DOCKETED	
Docket Number:	25-BSTD-03
Project Title:	2028 Energy Code Pre-Rulemaking.
TN #:	271515
Document Title:	Merrian Borgeson, NRDC Comments - NRDC Comments on June 23 Workshop and CASE Reports
Description:	N/A
Filer:	System
Organization:	Merrian Borgeson, NRDC
Submitter Role:	Public
Submission Date:	7/17/2026 11:15:43 AM
Docketed Date:	7/17/2026

NRDC Comments on June 23 Workshop and CASE Reports

July 17, 2026

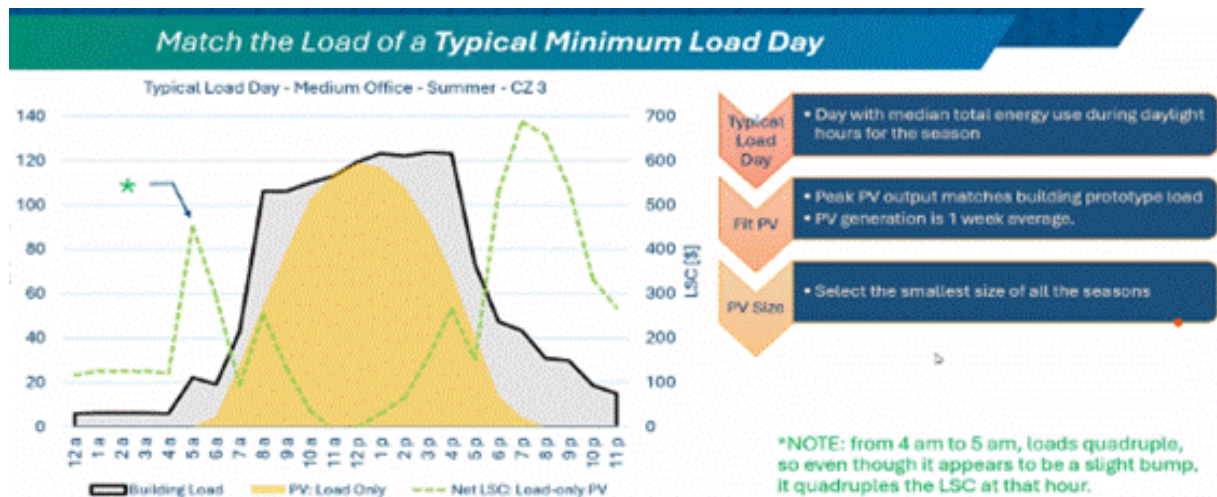
While we strongly support the CEC's efforts on this measure, we recommend that the CEC work to strengthen the impact of the proposal, by applying the requirements to more climate zones where the CEC's analysis shows heat pump RTUs to be cost-effective. Currently many climate zones are excluded due to lack of an alternative gas pathway. We recommend that the CEC consider whether any of the following options would allow for the development of a gas pathway to support the inclusion of additional climate zones:

- Referencing NEEA's Advanced Performance RTU specification which requires low leakage dampers and enclosure insulation. Based on NEEA's modeling, enclosure insulation alone can save approximately 3% on a gas RTU in San Diego.
- Requiring increased cooling efficiency for gas RTUs. Based on NEEA modeling, this could save an additional 2.5% on a gas RTU in San Diego.
- Making the gas pathway a dual fuel pathway that utilizes the efficiency of a heat pump to allow for the installation of a gas RTU.
